Our Ref: B3031

Re: Minto Resource Recovery Facility (SSD-5339)
3 November 2021 - Request for additional information

We refer to the subject request for additional information and provide below our response to the issues raised. Issues raised are shown in green with responses provided.

Project No:	Drawing No:
2021/0276	2021-276-04C

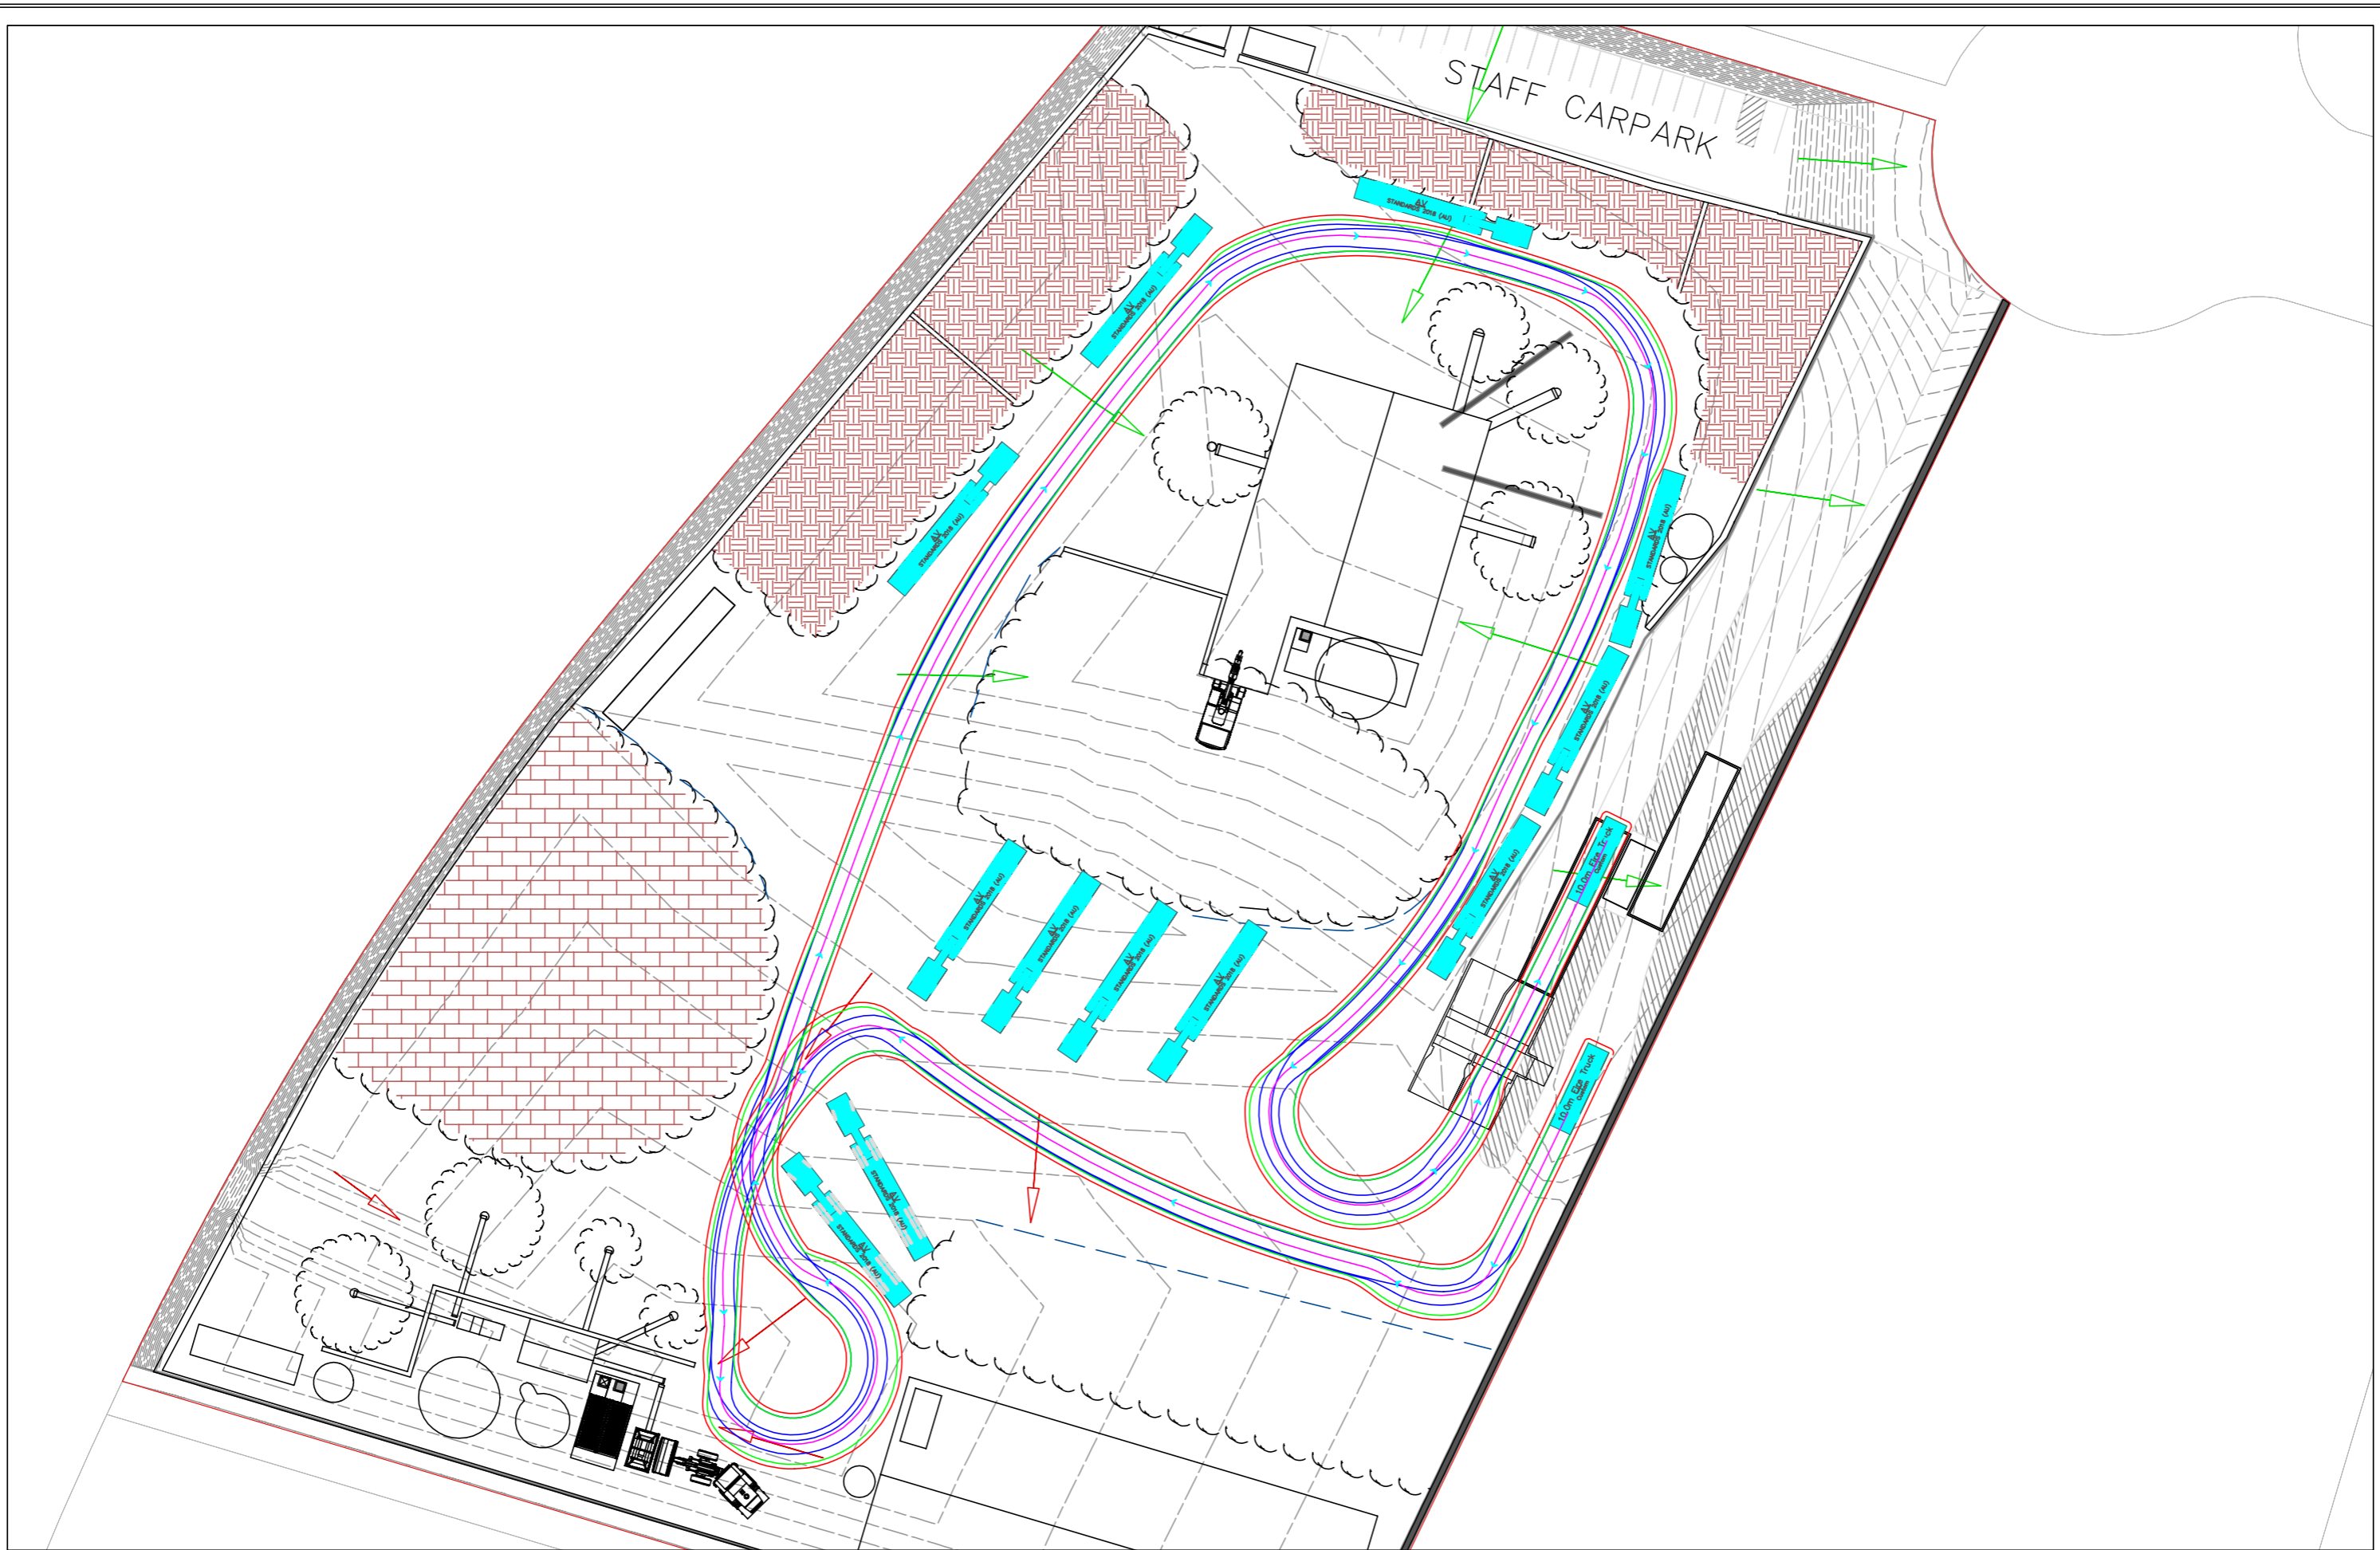
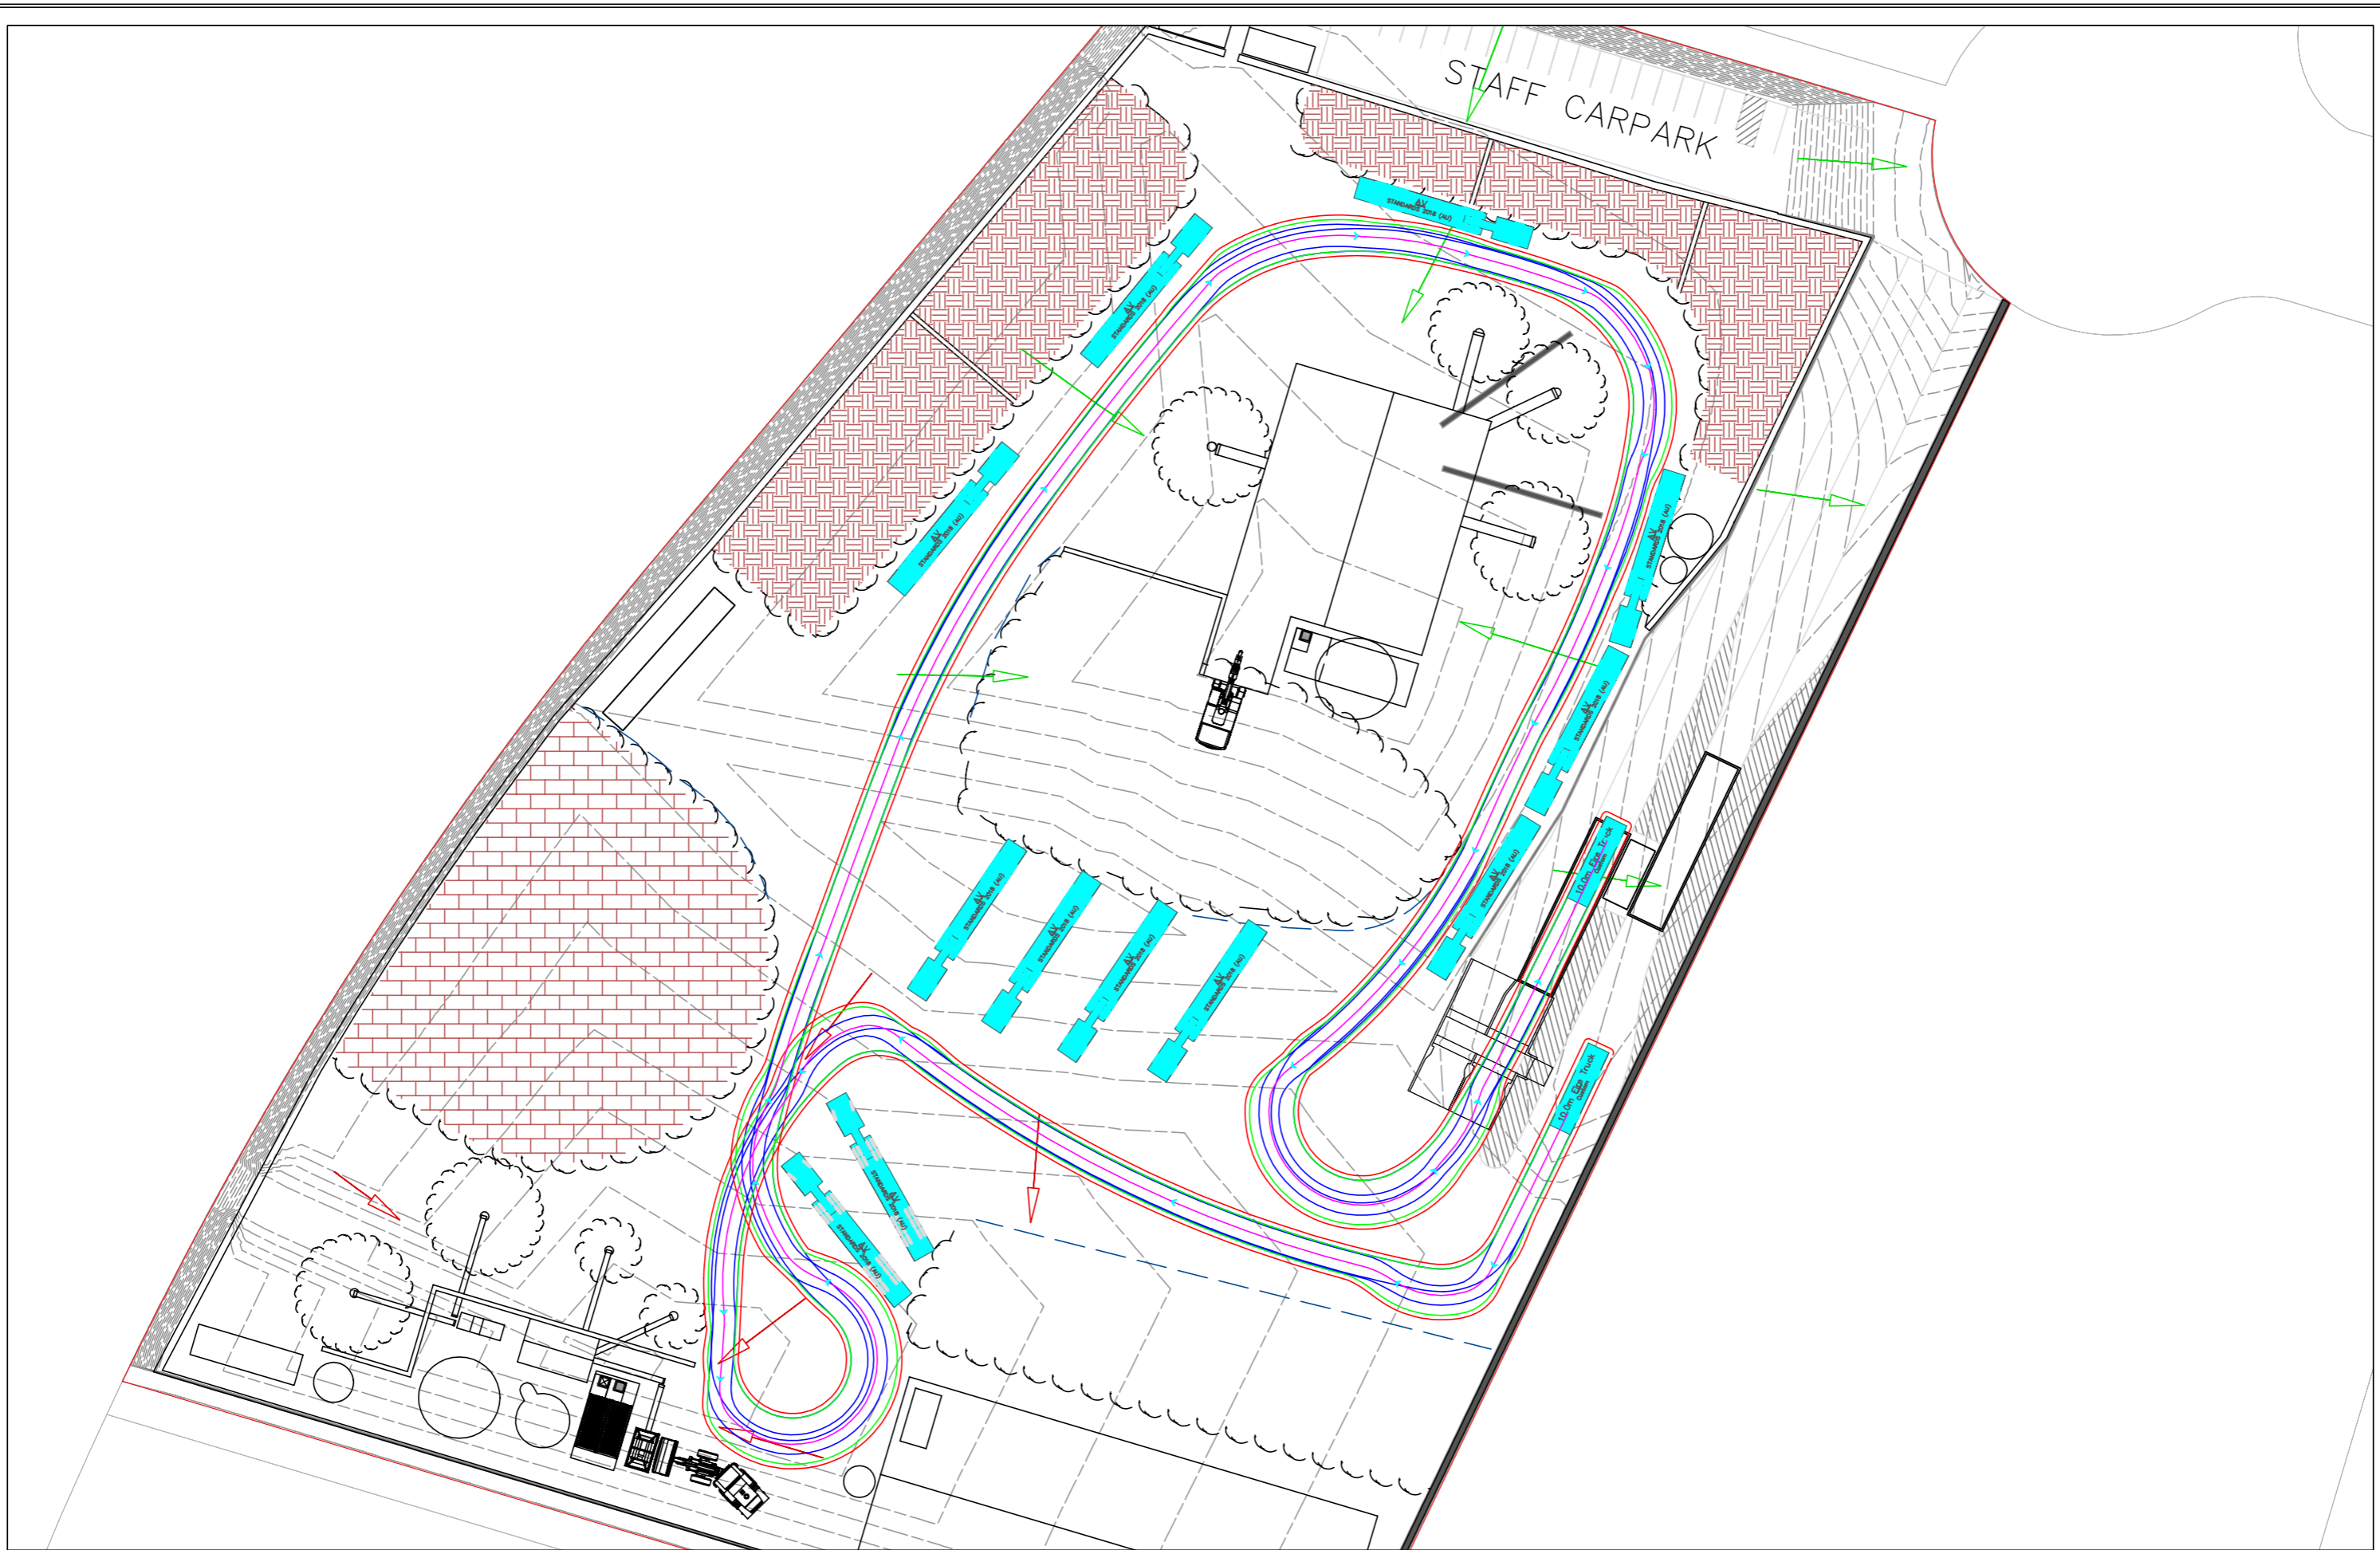
The Fire Engine swept path shown in Drawing No. 2021-276-04B runs over the unloading area adjacent to the sand stockpile, please amend.

Modified swept path diagrams have been prepared as shown in **Attachment 2** to this letter.

PROJECT NO.	PLANSET NO.	RELEASE NO.	DRAWING NO.	REVISION
P1203464	PS02	R25	PS02-A400	M

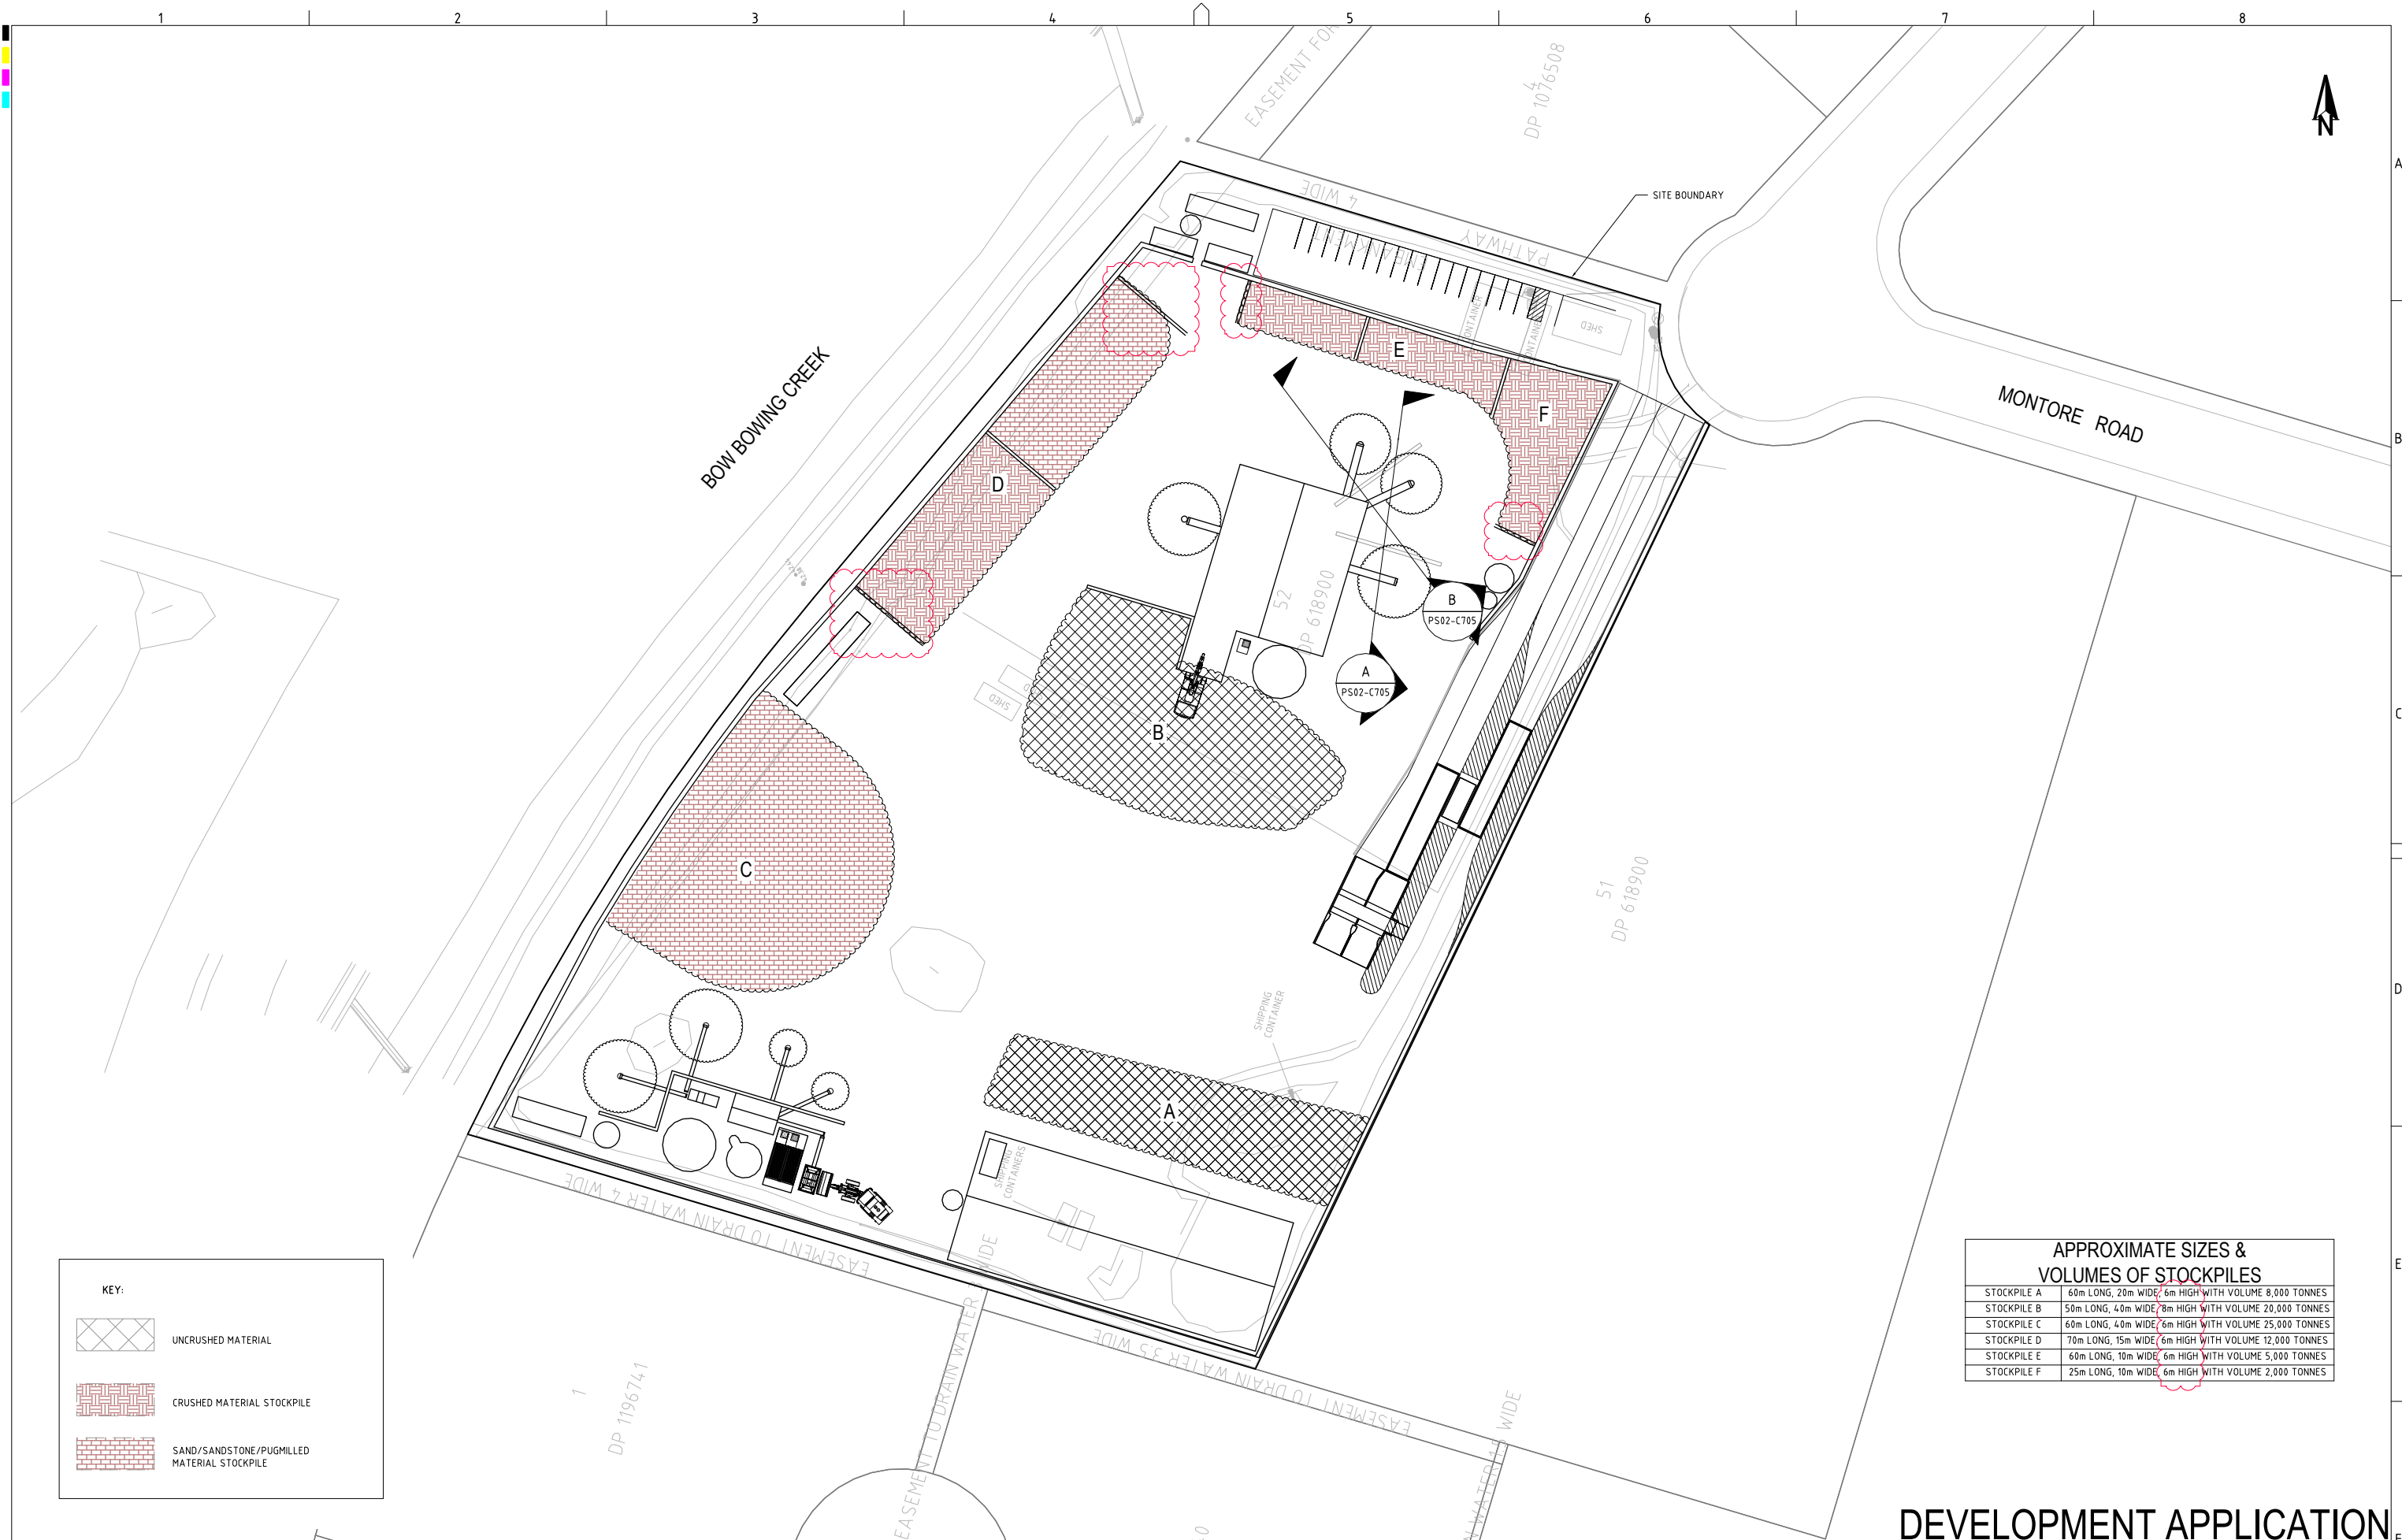
Plan PS02-A400	<p>Southern retaining wall, sand washing plant and shed moved into site by two (2) metres to allow drainage of overland flood water.</p> <p>Northern sediment basin removed and replaced with a pit and pump and an excess water storage tank (further details see Plan PS02-E100, Revision Q).</p> <p>Southern sediment basin removed and replaced with a pit and pump.</p> <p>Additional labelling as requested.</p>
Plan PS02-AZ00	Chain wire fence and clip lock fence on southern and eastern boundary replaced with concrete panel/Hebel fence.
Plan PS02-DZ01	Plan deleted.
Plan PS02-DZ02	Plan deleted.
Plan PS02-DZ03	Plan deleted.
Plan PS02-DZ04	Plan deleted.
Plan PS02-E100	<p>Northern drainage discharge removed.</p> <p>Northern water storage tank shown.</p> <p>Southern water storage tank increased to 450KL.</p> <p>Change to southern discharge to connect to existing infrastructure.</p>
Plan PS02-E200	Removal of sediment pits and replacement with pit and pump process where water is pumped into the treatment system before discharge.
